5484/5160

USE VARIANCE TO ALLOW THE CONSTRUCTION OF TWO 200' x 90' FLOAT BARNS IN A B-3, COMMUNITY BUSINESS DISTRICT; FLOAT BARNS ARE ALLOWED WITH PLANNING APPROVAL IN A B-4, GENERAL BUSINESS DISTRICT AND ALLOWED BY RIGHT IN AN I-1, LIGHT INDUSTRY DISTRICT.

BOARD OF ZONING ADJUSTMENT AUGUST 2008

ANALYSIS APPLICATION 5484/5160

SITE PLAN

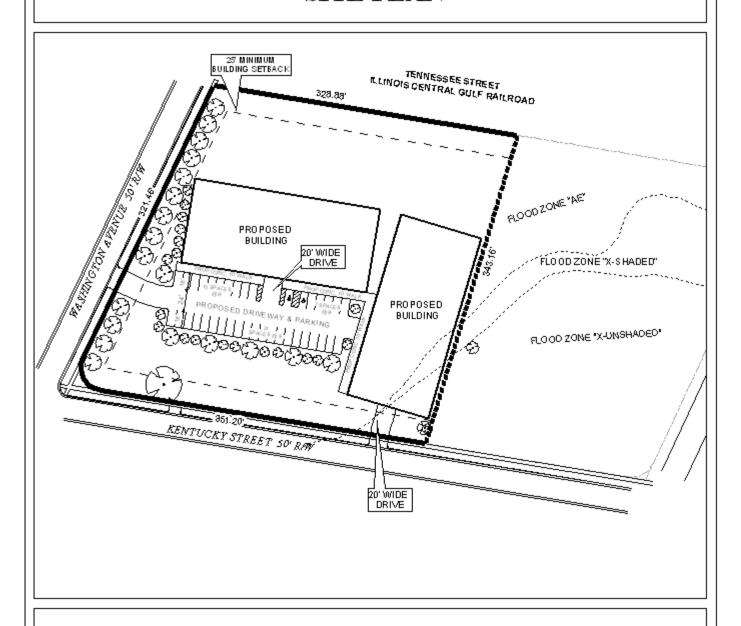
A note on the Subdivision plat states "Preservation status is to be given to the 44" Live Oak located on the south side of Lot 1. Any work on or under this tree is to be permitted and coordinated with Urban Forestry; removal to be permitted only in the case of disease or impending danger". Upon a review of the site plan submitted with this application, Urban Forestry has concerns with the location of the southern-most building in relation to the critical root zone of the tree and advises that the building should be relocated to clear the critical root zone. Therefore, the site plan should be revised, with the building relocation to be coordinated with Urban Forestry.

Since the approval of a variance is site plan specific, the applicant should revise the site plan to comply with the curb cut condition of the approved subdivision, and relocate the southern building to clear the critical root zone of the 44" Live Oak tree, with the relocation to be coordinated with Urban Forestry. This application should be held over to the meeting of August 4th to allow the applicant to make such revisions. A revised site plan should be submitted to the Planning Section no later than July 16.

This application was held over from the July meeting. The applicant has revised the site plan to address the excess curb cuts along Washington Avenue and the building encroachment into the 44" Live Oak tree critical root zone.

The site plan tree planting calculations do not address any plantings along Kentucky Street and should be revised for such. Also, the variable width Alabama Power Company easement along the Northern portion of the site is not indicated as on site plans for previous applications associated with this site. This easement should be shown on site plans submitted for land disturbance and construction, and the tree plantings along Washington Avenue should be revised to allow for the easement. Urban Forestry has indicated that tree plantings in the vicinity of the Washington Avenue and Kentucky Street drives should be located so as to allow for floats to clear the canopies as the trees mature.

Based on the preceding, this application is recommended for approval, subject to the following conditions: 1) revision of the site plan for land disturbance and construction permitting to indicate full compliance with the landscaping and tree planting requirements of the Zoning Ordinance; 2) inclusion of the Alabama Power Company easement along the Northern portion of the site with adjusted tree plantings within along Washington Avenue; 3) location of tree plantings in the vicinity of the Washington Avenue and Kentucky Street drives to allow for float clearance as trees mature; and 4) preservation status is to be given to the 44" Live Oak located on the south side of the site. Any work on or under this tree is to be permitted and coordinated with Urban Forestry; removal to be permitted only in the case of disease or impending danger.
